Access Compliance Report

Public Rights-of-Way

(Island Curb Cuts)

Intersection ID: 8626	Main Street: N_TRYON_ST	Cross Street: NORTHCHASE_DR	Location: NW
ADA ID: E363688C25B3	Curb Cut Type: MedianRefuge2	Initial Pass/Fail: Fail	Overall Compliance: No
Severity Score: 33.75			
Codes/Mitigation Info/Possible Solution		Field Measurements/Component Compliance

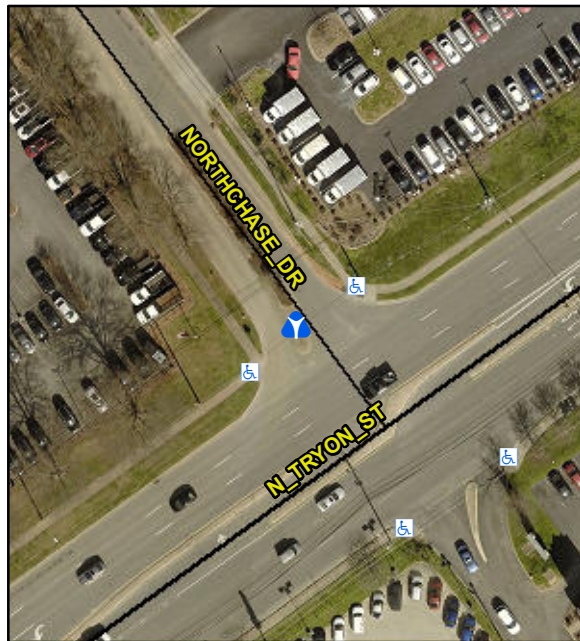
Compliance	Description	Data	Compliance	Description	Data
No	Refuge 1 Length (In)	34.5	N/A	Gutter 1 Ponding?	N/A
No	Refuge 1 Width (In)	38.0	N/A	Gutter 1 Lip Ht (In)	N/A
Yes	Refuge 1 Slope (%)	2.1	N/A	Gutter 1 Slope (%)	N/A
Yes	Refuge 1 X Slope (%)	0.1	N/A	Gutter 1 X Slope (%)	N/A
N/A	Painted X Walk1?	No	N/A	DWS 1 Provided?	N/A
N/A	X Walk 1 Direction	To E	N/A	DWS 1 Contrast?	N/A
N/A	X Walk 1 Width (In)	N/A	N/A	DWS 1 Length (In)	N/A
N/A	Road 1 Slope (%)	1.4	N/A	DWS 1 Full Width?	N/A
N/A	Road 1 X Slope (%)	1.3	N/A	DWS 1 Offset (In)	N/A
No	Refuge 2 Length (In)	34.5	N/A	Gutter 2 Ponding?	N/A
No	Refuge 2 Width (In)	38.0	N/A	Gutter 2 Lip Ht (In)	N/A
Yes	Refuge 2 Slope (%)	2.2	N/A	Gutter 2 Slope (%)	N/A
Yes	Refuge 2 X Slope (%)	0.2	N/A	Gutter 2 X Slope (%)	N/A
N/A	Painted X Walk2?	No	N/A	DWS 2 Provided?	N/A
N/A	X Walk 2 Direction	To W	N/A	DWS 2 Contrast?	N/A
N/A	X Walk 2 Width (In)	N/A	N/A	DWS 2 Length (In)	N/A
N/A	Road 2 Slope (%)	1.2	N/A	DWS 2 Full Width?	N/A

N/A	Road 2 X Slope (%)	1.9	N/A	DWS 2 Offset (In)	N/A
N/A	Refuge 3 Length (in)	N/A	N/A	Gutter 3 Ponding?	N/A
N/A	Refuge 3 Width (in)	N/A	N/A	Gutter 3 Lip Ht (in)	N/A
N/A	Refuge 3 Slope (%)	N/A	N/A	Gutter 3 Slope (%)	N/A
N/A	Refuge 3 XSlope (%)	N/A	N/A	Gutter 3 XSlope (%)	N/A
N/A	Painted X Walk3?	N/A	N/A	DWS 3 Provided?	N/A
N/A	X Walk 3 Direction	N/A	N/A	DWS 3 Contrast?	N/A
N/A	X Walk 3 Width (in)	N/A	N/A	DWS 3 Length (in)	N/A
N/A	Road 3 Slope (%)	N/A	N/A	DWS 3 Full Width?	N/A
N/A	Road 3 XSlope (%)	N/A	N/A	DWS 3 Offset (in)	N/A
Yes	Any Obstructions?	N/A	N/A	Storm Grate/Utility Hazard?	N/A
N/A	Obstruction Type		N/A	Storm Grate/Utility Type	
		N/A			N/A
No	Surface Condition	Poor

Remove & Replace Entire Refuge.
